# Access Compliance Report

## Public Rights-of-Way

Intersection ID: 47573	Main Street: SEDGEBURN_DR	Cross Street: GAILES_DR	Location: SE
ADA ID: 5037B340D3BC	Ramp Type: PerpDiag	Initial Pass/Fail: Fail	Overall Compliance: No
Severity Score: 8.75			
Codes/Mitigation Info/Possible Solution		Field Measurements/Component Compliance

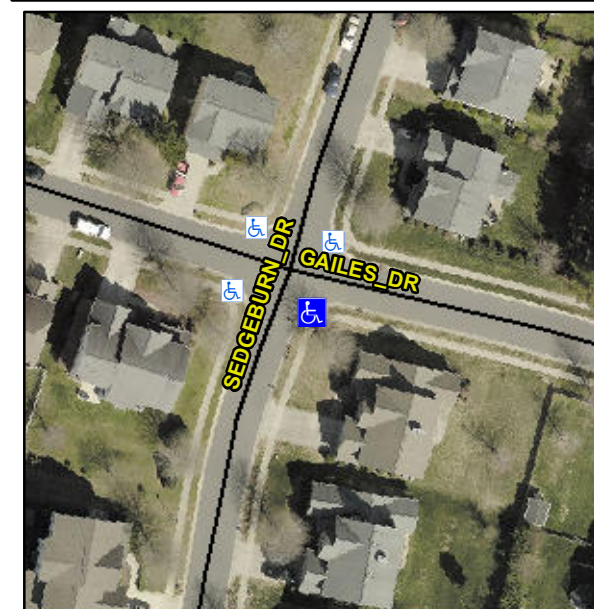
**Not Found, R304.5.1**

Compliance	Description	Data	Compliance	Description	Data
N/A	Ramp Length (in)	48.0	Yes	Ramp Slope (%)	8.2
No	Ramp Width (in)	42.5	Yes	Ramp XSlope (%)	1.1
N/A	Flare Type LT	N/A	N/A	Flare Type RT	N/A
N/A	Flare Slope LT (%)	N/A	N/A	Flare Slope RT (%)	N/A
N/A	Flare Traversable LT?	N/A	N/A	Flare Traversable RT?	N/A
N/A	Landing Length (in)	N/A	N/A	DWS Provided?	N/A
N/A	Landing Width (in)	N/A	N/A	DWS Contrast?	N/A
N/A	Landing Slope (%)	N/A	N/A	DWS Length (in)	N/A
N/A	Landing X Slope (%)	N/A	N/A	DWS Full Width?	N/A
N/A	Landing Curb? (Y/N)	N/A	N/A	DWS Offset (in)	N/A
N/A	Shared Landing?	N/A			
N/A	Gutter Ponding?	N/A	N/A	Gutter Slope (%)	N/A
N/A	Gutter Lip Ht (in)	N/A	N/A	Gutter X Slope (%)	N/A
N/A	Painted X Walk1?	No	N/A	Painted X Walk2?	No
	X Walk 1 Direction	To NE		X Walk 2 Direction	To NW
N/A	X Walk 1 Width (in)	N/A	N/A	X Walk 2 Width (in)	N/A
	X Walk 1 Slope (%)	0.4		X Walk 2 Slope (%)	0.6
	X Walk 1 X Slope (%)	1.3		X Walk 2 X Slope (%)	1.8

**Remove & Replace Curb Ramp With Two New Directional Ramps or Equivalent.**
